Access Compliance Report

Public Rights-of-Way

(Curb Ramps)

Intersection ID: 12877	Main Street: E_5TH_ST	Cross Street: N_MYERS_ST	Location:	N
ADA ID: 04DE8A99824B	Ramp Type: Combination1Diag	Initial Pass/Fail: Fail	Overall Compliance: No	Severity Score: 0

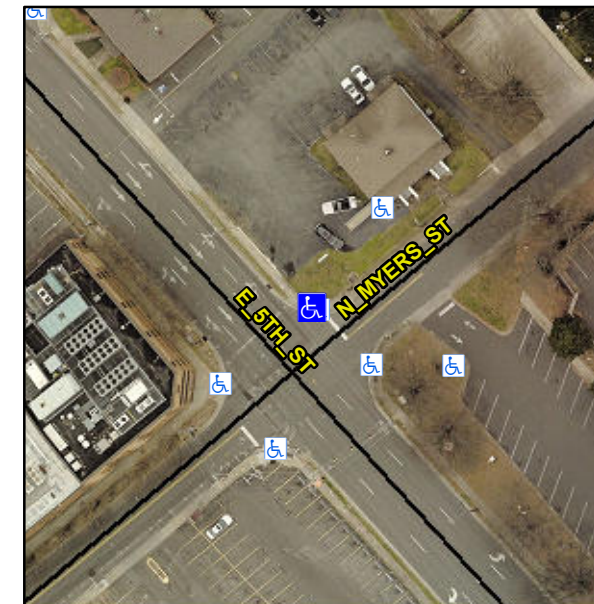
Not Found, R304.5.1, R304.2.2, R304.5.3, R304.3.2

Compliance	Description	Data	Compliance	Description	Data
N/A	Ramp Length LT (in)	51.0	N/A	Ramp Length RT (in)	55.0
No	Ramp Width LT (in)	34.0	No	Ramp Width RT (in)	33.0
No	Ramp Slope LT (%)	12.6	Yes	Ramp Slope RT (%)	8.1
Yes	Ramp XSlope LT (%)	0.9	No	Ramp XSlope RT (%)	5.9
N/A	Ramp Length (in)	25.0	No	Ramp Slope (%)	11.1
Yes	Ramp Width (in)	48.0	No	Ramp XSlope (%)	6.2
N/A	Flare Type LT	N/A	N/A	Flare Type RT	N/A
N/A	Flare Slope LT (%)	N/A	N/A	Flare Slope RT (%)	N/A
N/A	Flare Traversable LT?	N/A	N/A	Flare Traversable RT?	N/A
N/A	Landing Length (in)	N/A	N/A	DWS Provided?	N/A
N/A	Landing Width (in)	N/A	N/A	DWS Contrast?	N/A
N/A	Landing Slope (%)	N/A	N/A	DWS Length (in)	N/A
N/A	Landing X Slope (%)	N/A	N/A	DWS Full Width?	N/A
N/A	Landing Curb? (Y/N)	N/A	N/A	DWS Offset (in)	N/A
N/A	Shared Landing?	N/A			
N/A	Gutter Ponding?	N/A	N/A	Gutter Slope (%)	N/A
N/A	Gutter Lip Ht (in)	N/A	N/A	Gutter X Slope (%)	N/A
N/A	Painted X Walk1?	No	N/A	Painted X Walk2?	No

Remove & Replace Curb Ramp With Two New Directional Ramps or Equivalent.
